## **ADDENDUM NO. 2:**

Date: June 30, 2015  
 Project: Alberta Technology Center  
 Owner: The City of Tuscaloosa  
 Owner's Project No: A15-0513  
 Architect: Ward Scott Architecture, Inc.

This Addendum forms a part of the Contract Documents and modifies the original Bid Documents dated June 22, 2015, as noted below.

1 ROOF PLAN - UPPER ROOF PLAN  
1/4" = 1'-0"

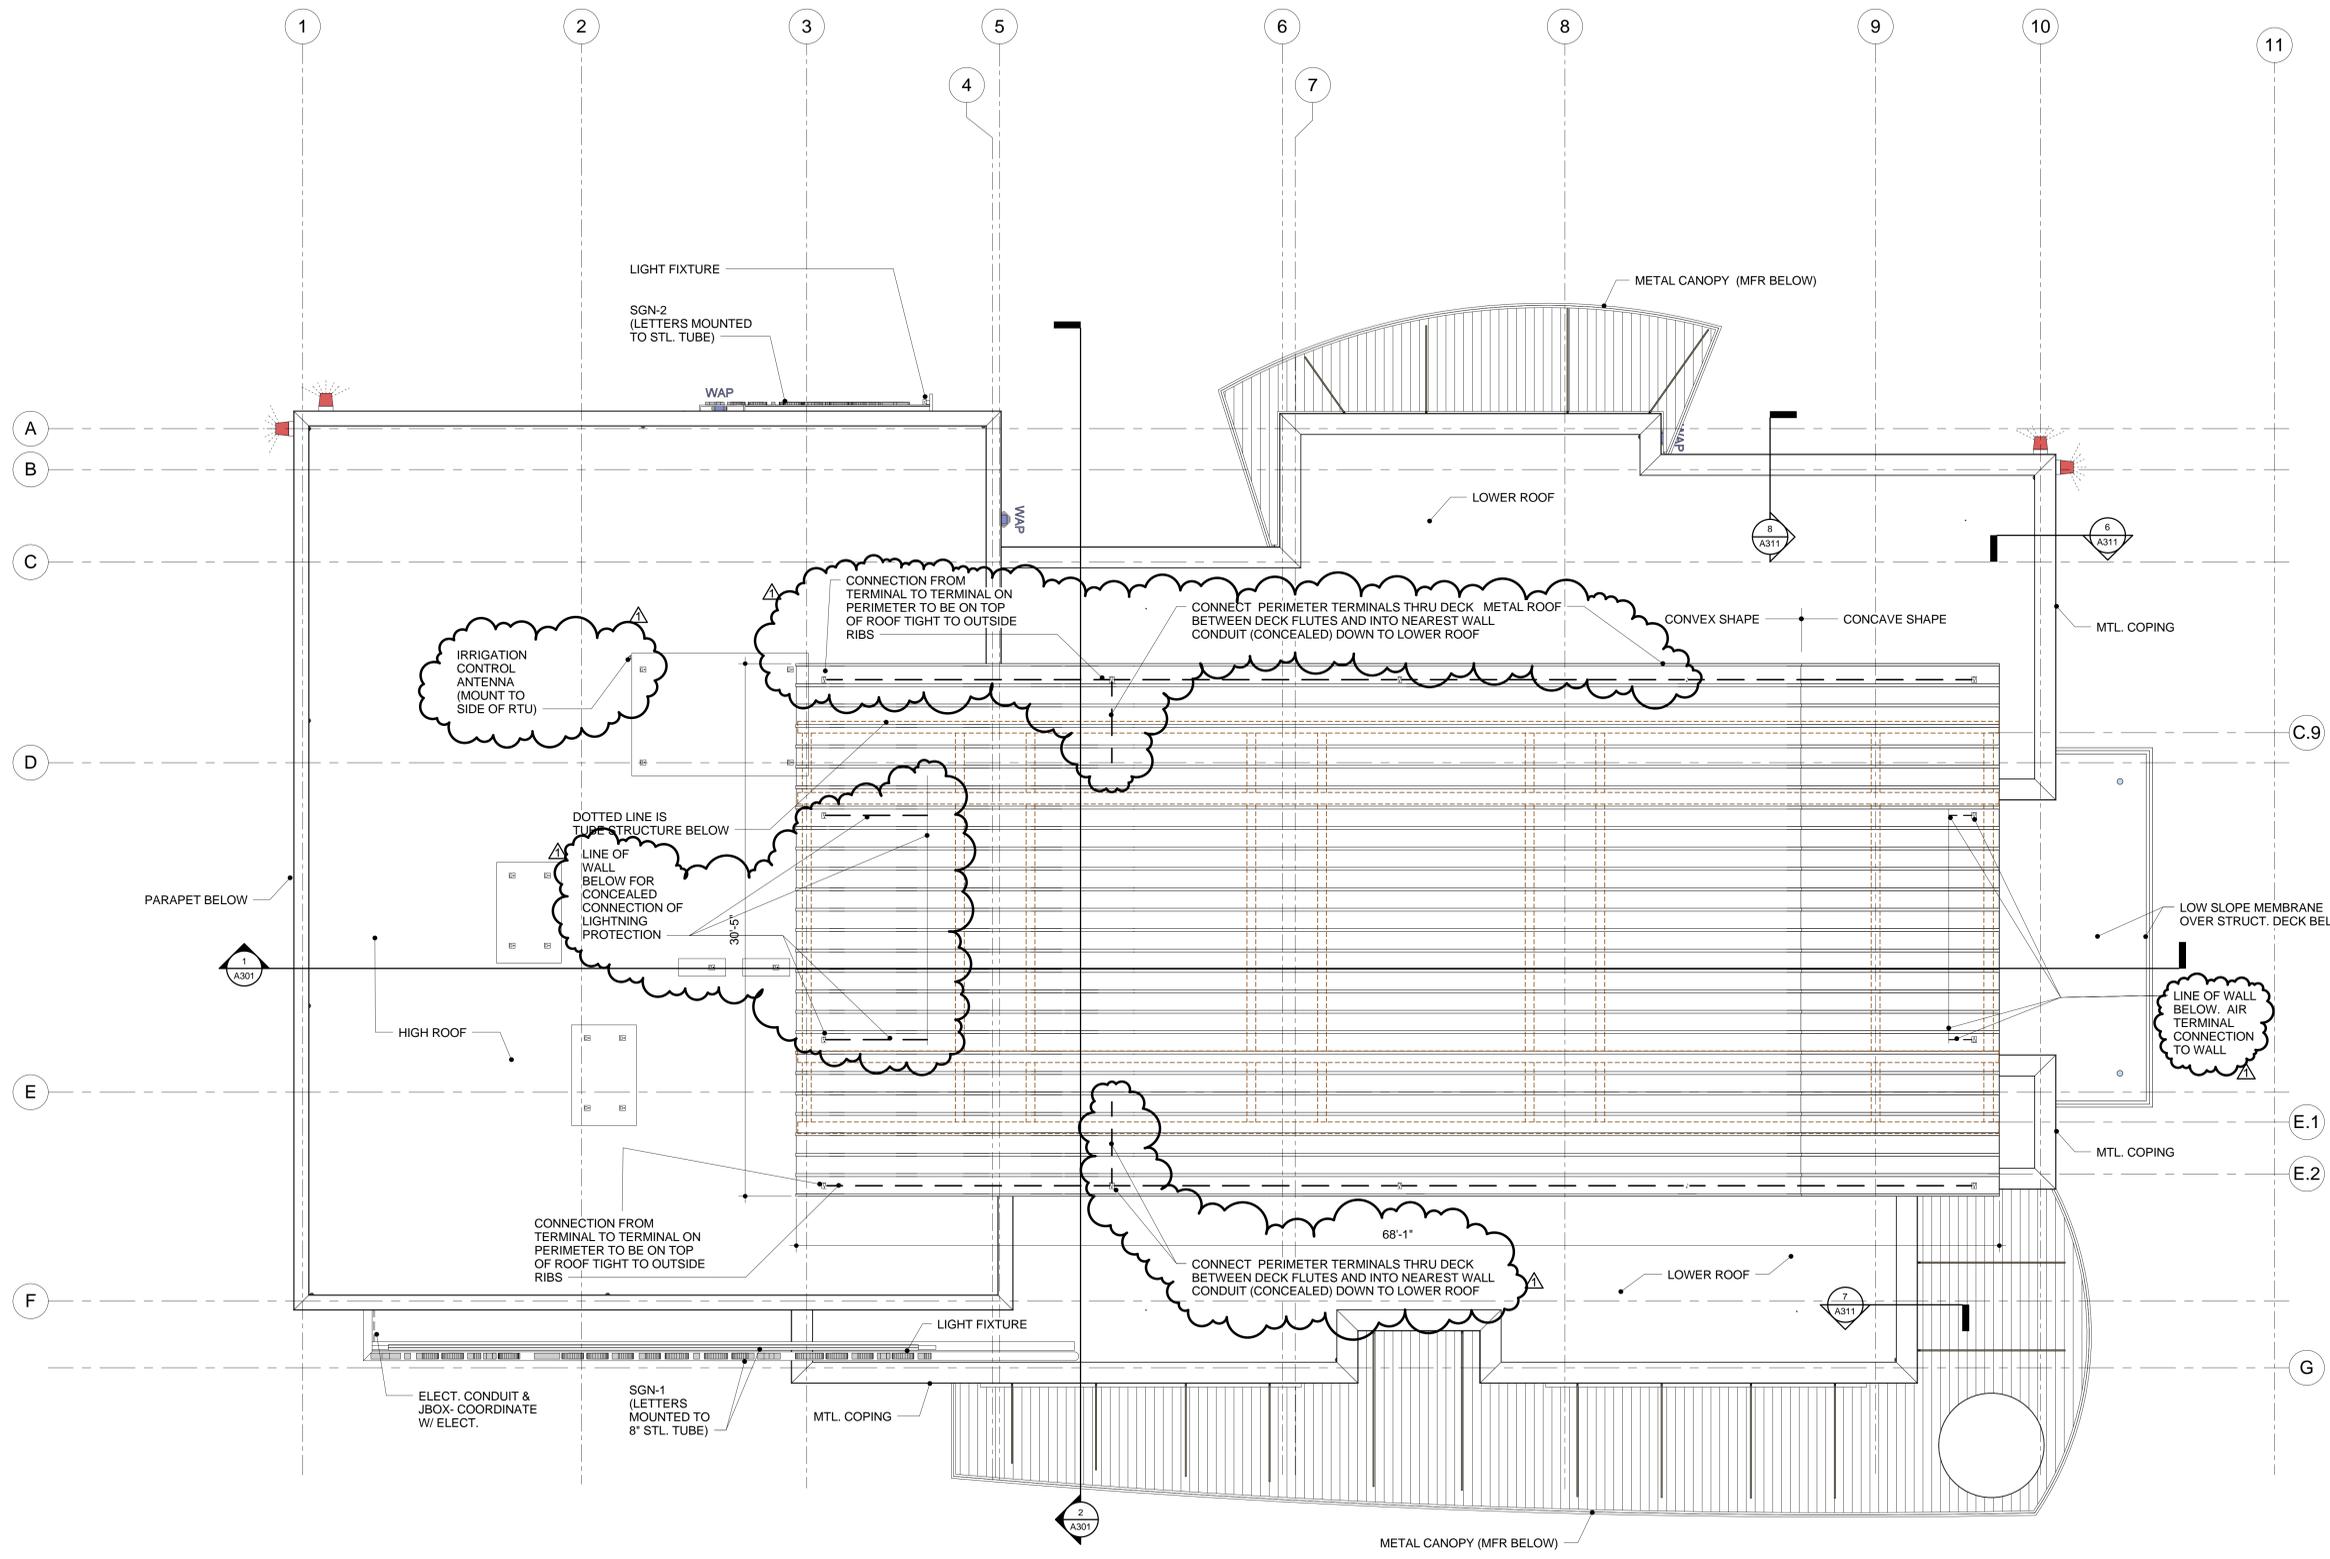
2. Refer to Sheet AC03 Site Plan Details, Detail 3 has been replaced.
  3. Refer to Sheet A104 Upper Roof Plan
    - a. Lightning protection system has been updated to reflect connection thru building to lower roof

**2** DETAIL - PREFAB CANOPY - TYP  
1 1/2" = 1'-0"

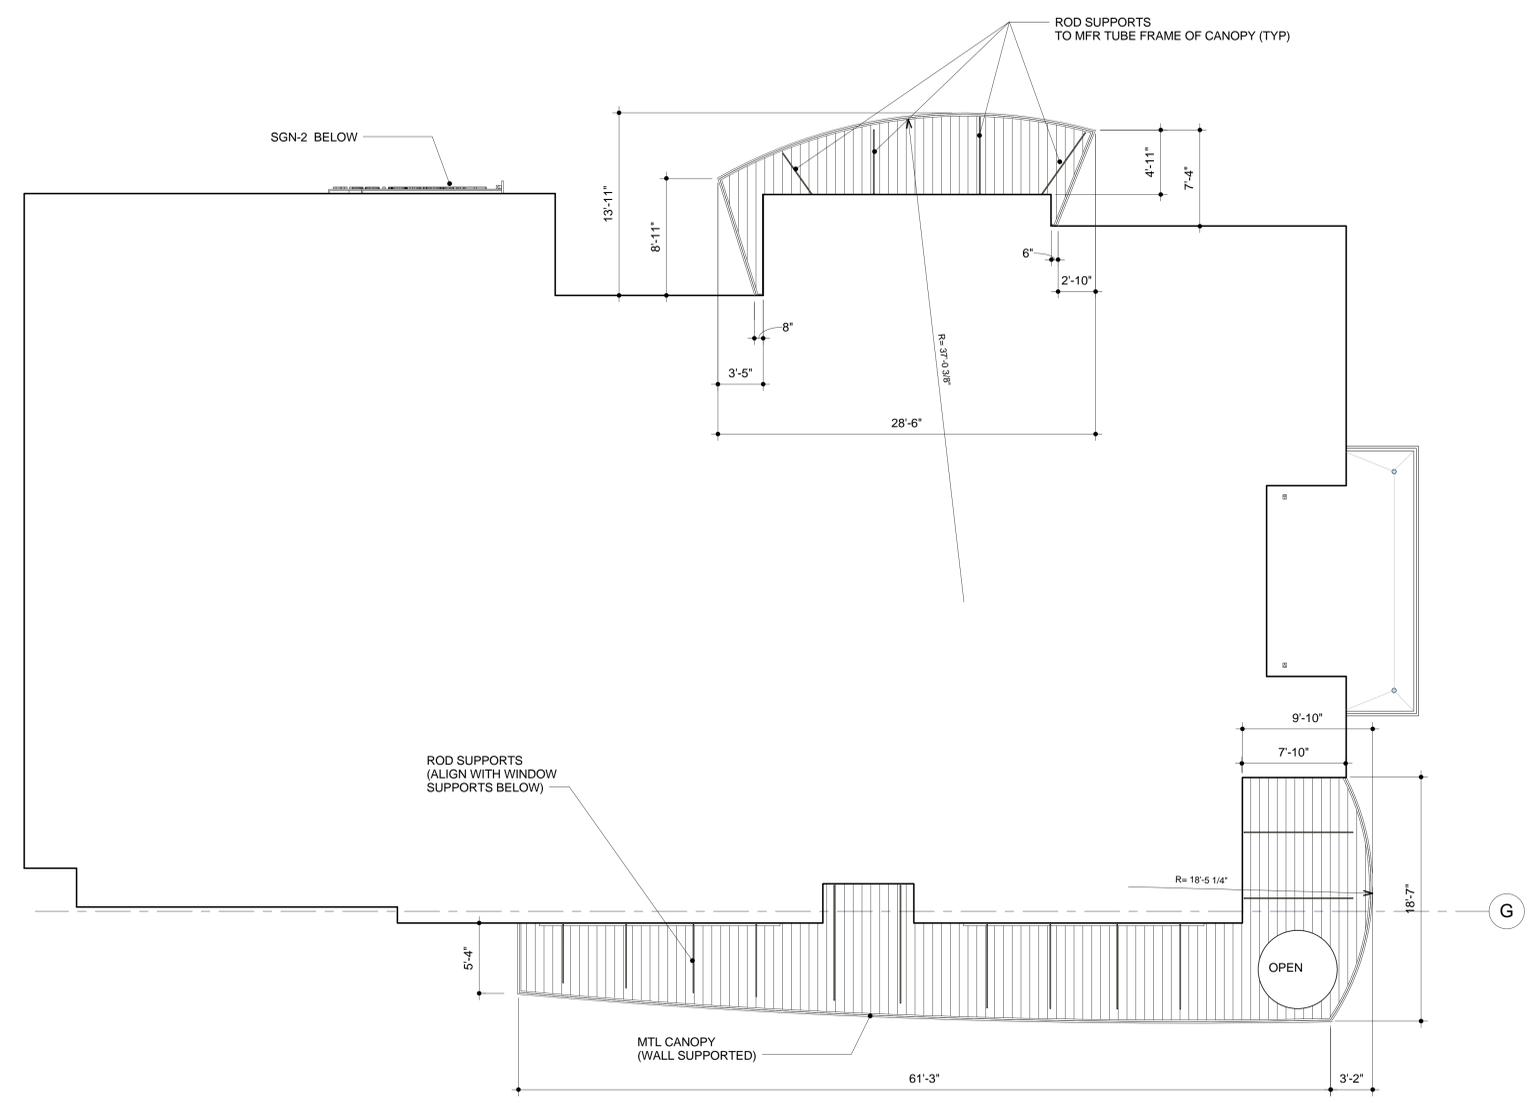
4. Refer to Sheet A105 Canopy Plan and Details
    - a. Detail 2 - Gussett/Lug note and dimensions have been added
  5. Refer to Sheet A111 Enlarged Floor Plan

1 DETAIL AT CURVED ROOF (UPPER)  
3" = 1'-0"

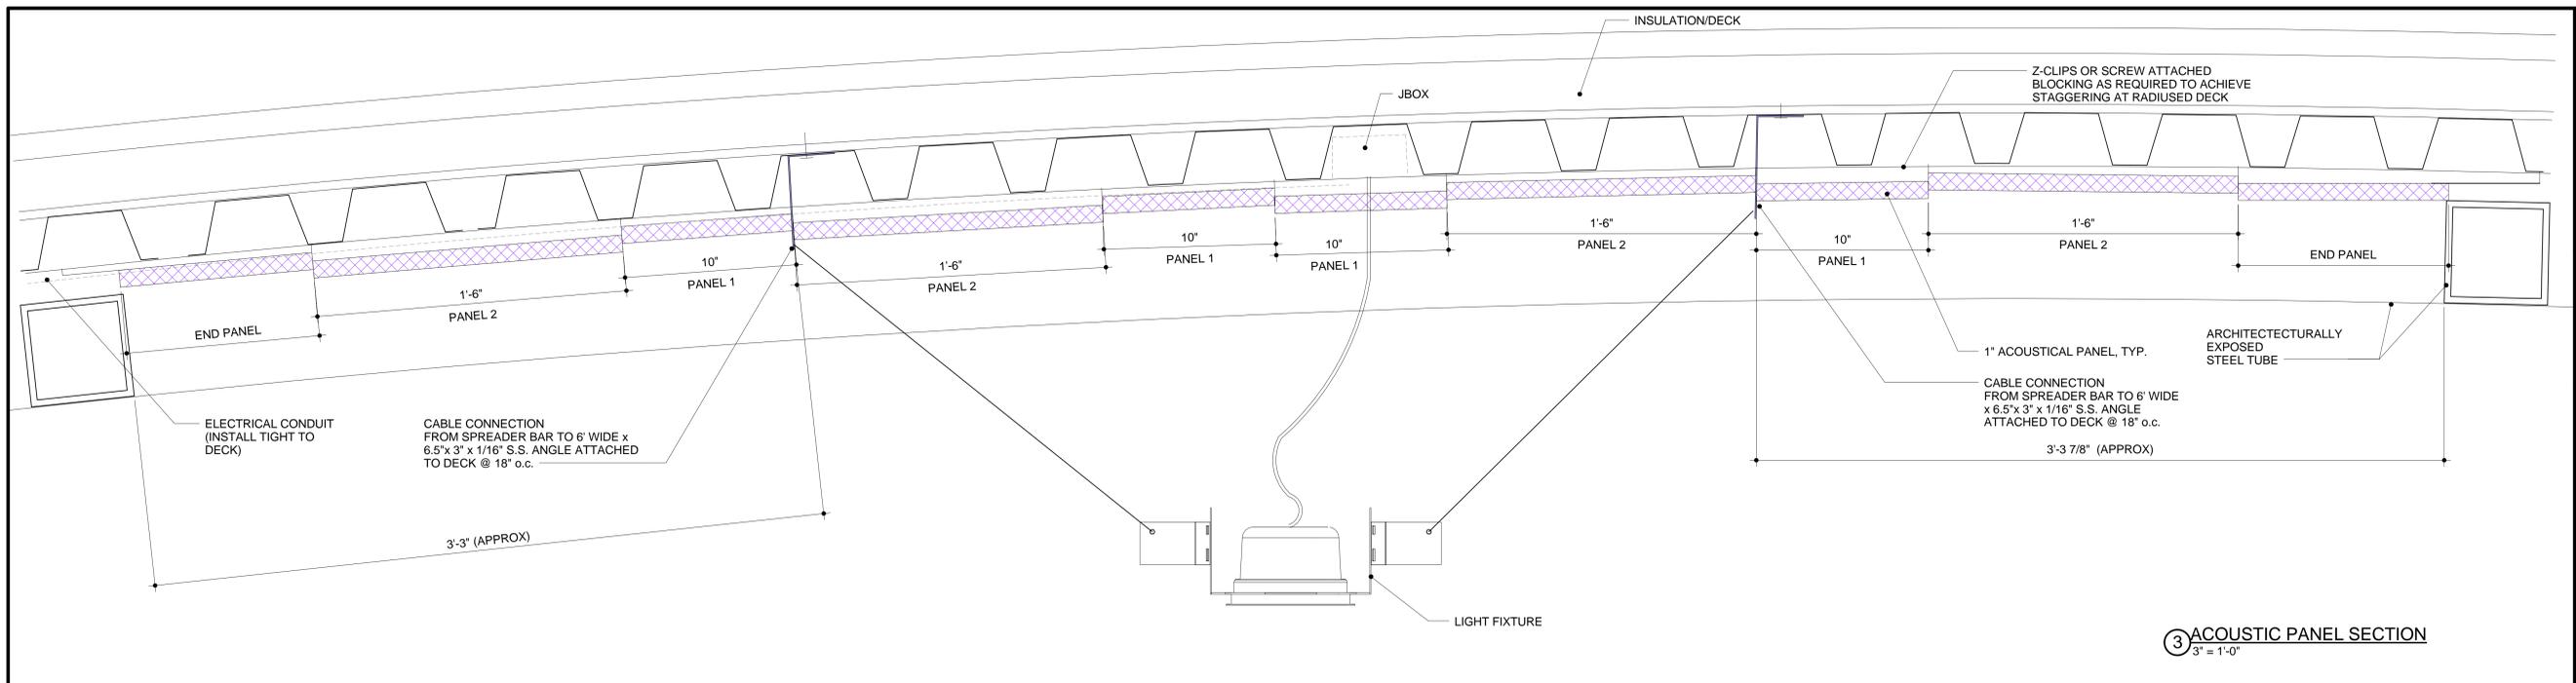
7. Refer to Sheet A312 Details Curved Roof
    - a. Detail 1 - Lightning protection system has been updated to reflect connection thru building to lower roof

11 PROFILE - WOOD TRIM (WD-2)  
6" = 1'-0"

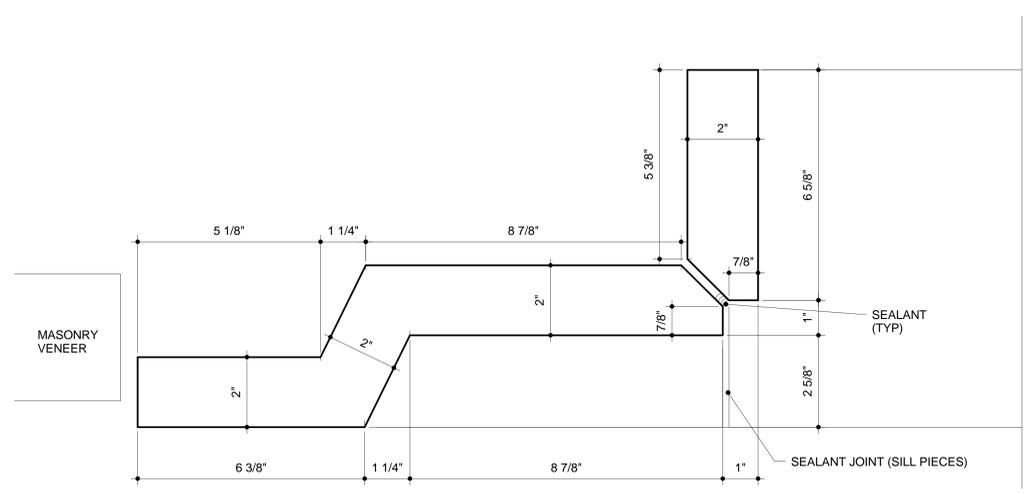
10. Refer to Sheet A331 Section Details
    - a. Detail 4 – solid surface sill and lip shown.
  11. Refer to Sheet A332 Typical Details
    - a. Detail 9 (New) – add ¾" x 2" painted wood wall trim
